Darling Square NW Plot
Design Report for Section 96 Application
(Mod 3) To Modify SSD 6013
October 2016

Approval for SSD 6013 Mod 2 was granted on 26 November 2015. This report has been prepared to support a section 96 application. It describes a range of minor amendments as the result of design development for the project.

Figure 4.06 : Proposed Atrium Roof Part Plan

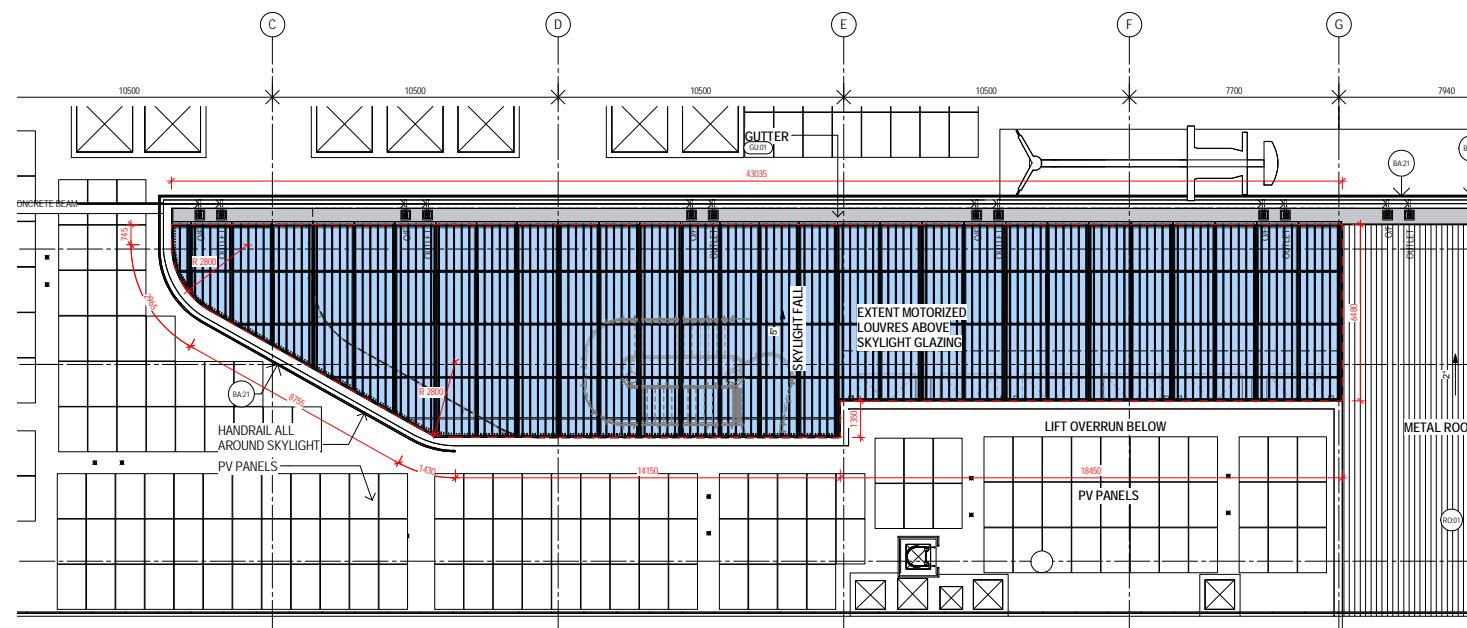
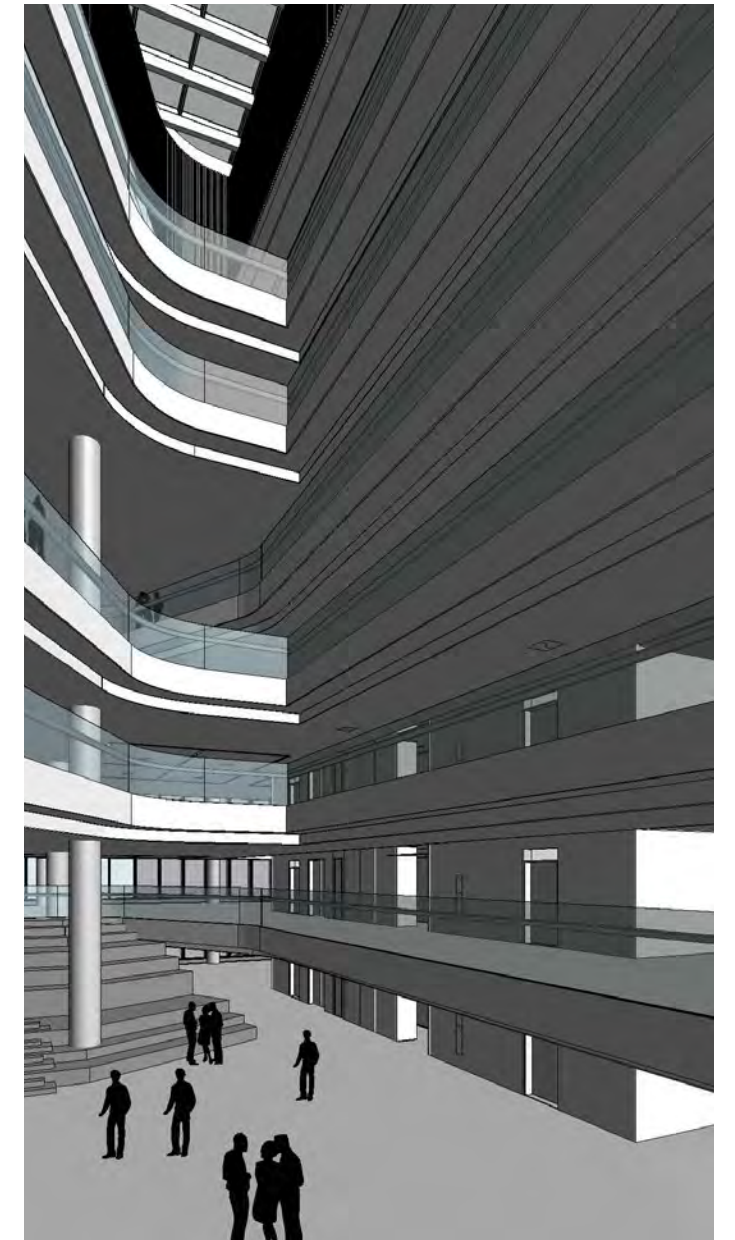
The glass roof shape on level 13 has been amended to mirror the floorplate below. Previously the glass roof extended into the plantroom creating an undesirable connection point to the architecture below.

The proposed adjustment to the glass line ensures that the curvilinear architectural language is maintained creating a strong view point from the atrium below.

Figure 4.08 : Proposed External Atrium Louvre Shading Blades

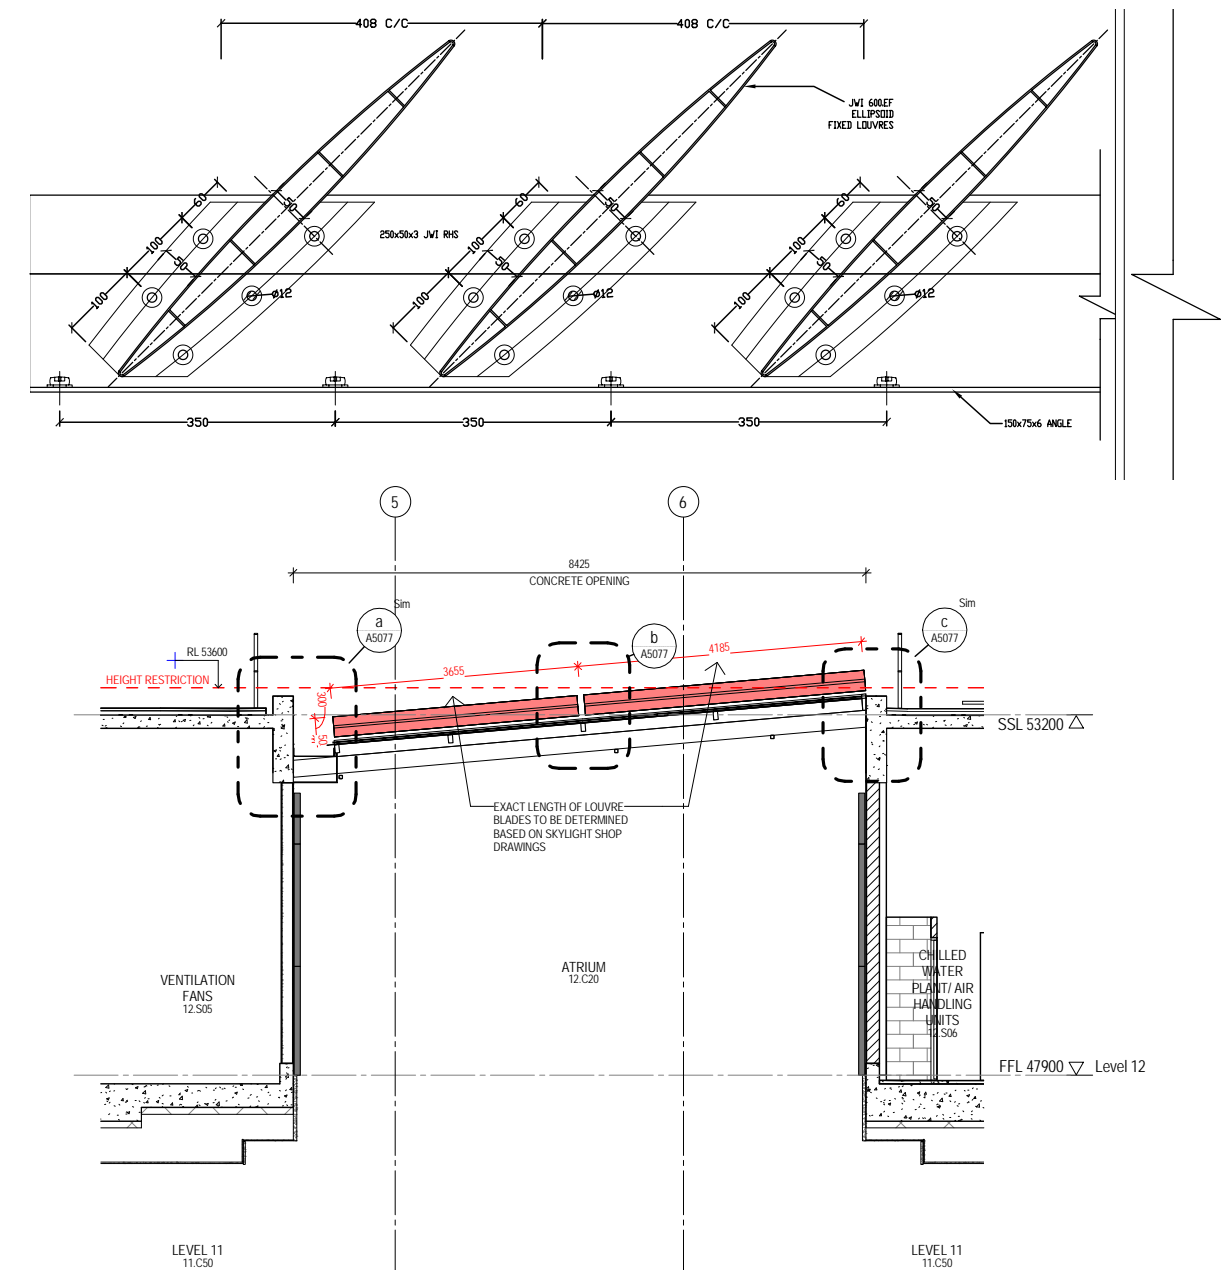
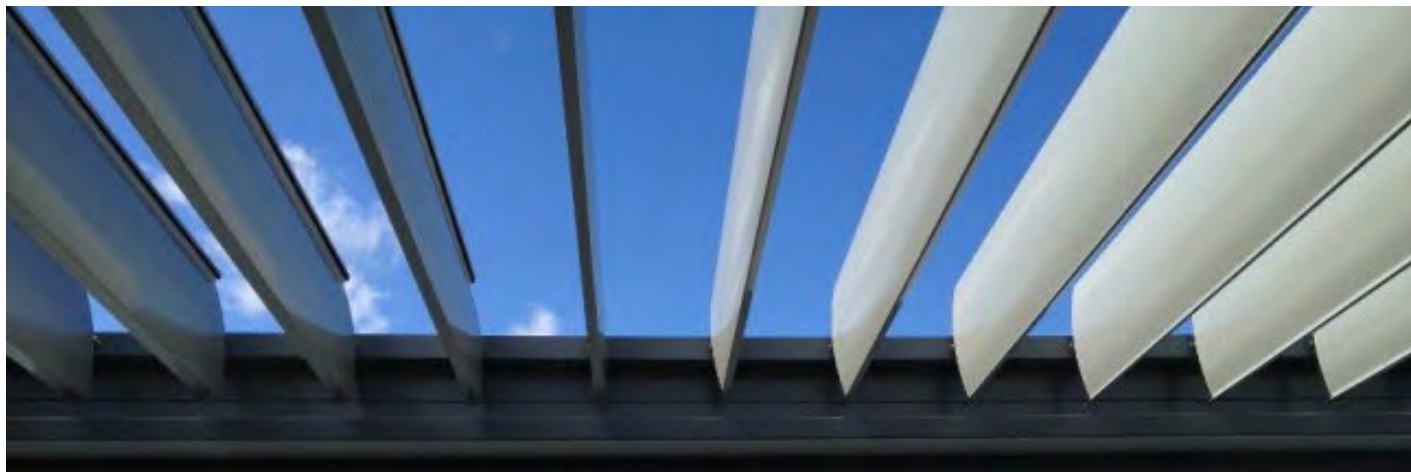
To ensure the most appropriate architectural solar protection response for the building and to allow for lower energy consumption, automated aluminium louvres have been incorporated externally above the atrium glazing. The chosen shading system consists of motorized aluminium louvre blades which are controlled by a solar tracker system that is programmed so that natural daylight is maximised within the building without creating discomfort to the occupants from direct overhead solar load. The louvre profiles also allow for views to the exterior from the atrium below. The inclusion of the system externally allows for ease of maintenance and cleaning.
